SERVICE BULLETIN

NUMBER: SB 500-31-009, REV B
MODEL: ECLIPSE EA500
SUBJECT: DIAGNOSTIC STORAGE UNIT (DSU) SPARES

DSU Removal / Installation
Figure 1 (Sheet 1 of 1)

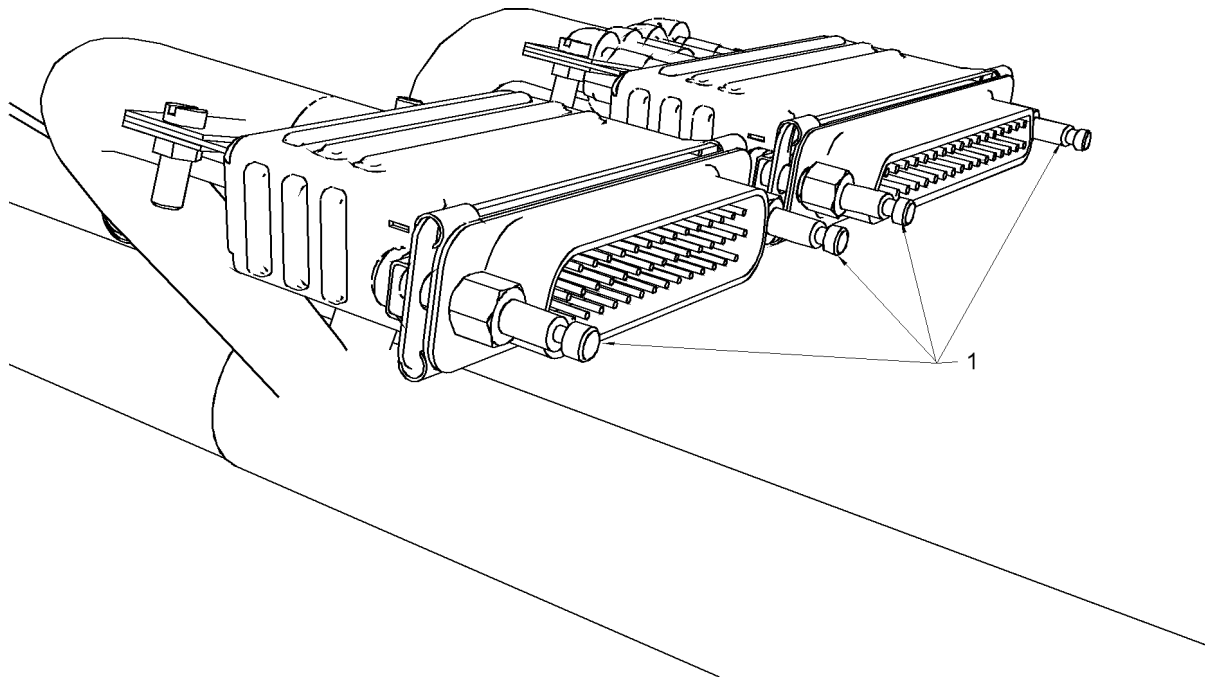
NOTE: DSU P/N 11-0323-07-A and the harness connector (8, Figure 1) and (1, Figure 2) can be identified by the slide style retention device (9, Figure 1) on the DSU.

- (8) Disconnect the electrical connectors 39A10P01 and 39A10P02 (1, Figure 1) and (3, Figure 1) from the DSU (6, Figure 1).
- (9) Disconnect coax connector 39A10P03 from the DSU.

- (10) Remove the eight bolts (5, Figure 1) and washers (4, Figure 1) that attach the DSU (6, Figure 1) to the rails (2, Figure 1) and (7, Figure 1).
- (11) Remove the DSU P/N 11-0323-07-A (6, Figure 1) from the rails (2, Figure 1) and (7, Figure 1).

39A10P01 and 39A10P02 Electrical Connectors
Figure 2 (Sheet 1 of 1)

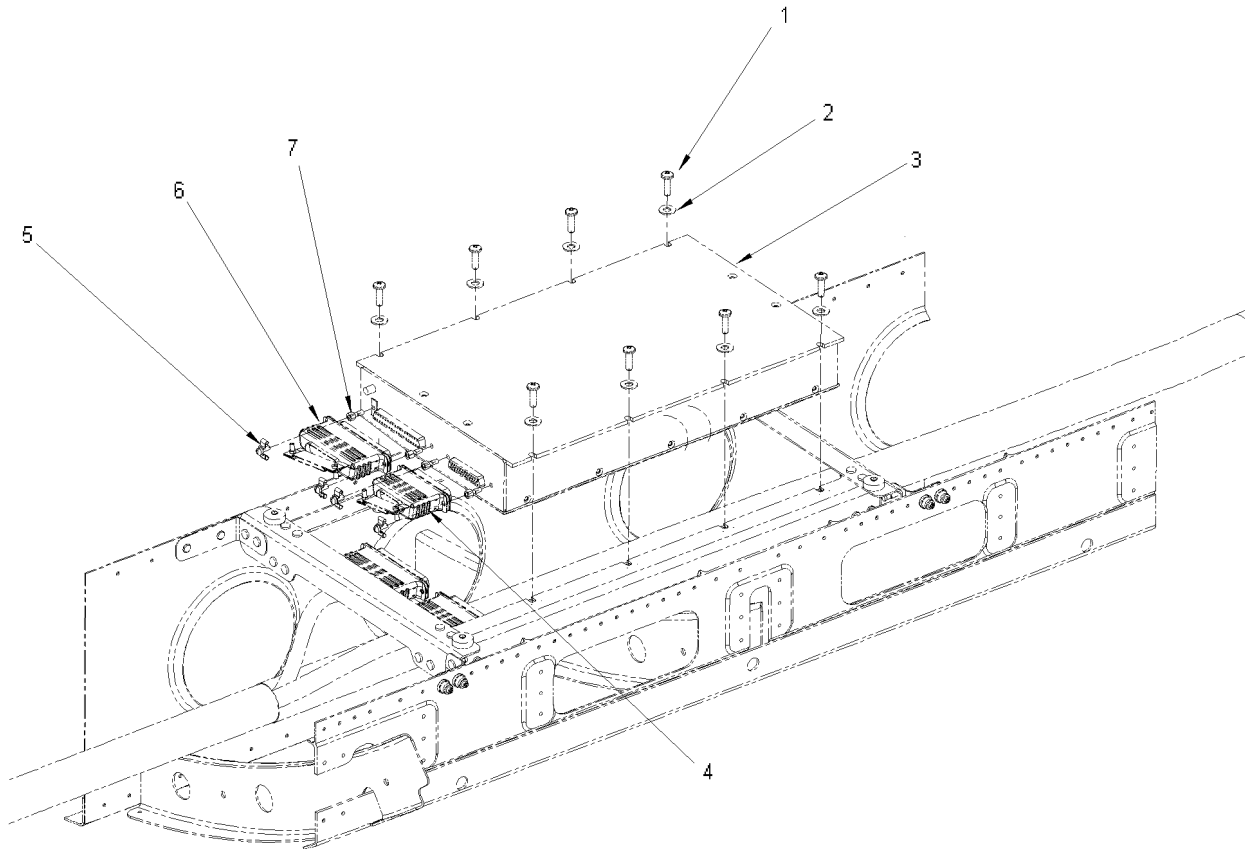
- (12) Remove and discard the attachment hardware (1, Figure 2) from the harness connectors at 39A10P01 and 39A10P02.
- (13) Attach the locking hardware P/N D20419-18 (5, Figure 3), one on each side of the connector on 39A10P01 (4, Figure 3) and 39A10P02 (6, Figure 3).
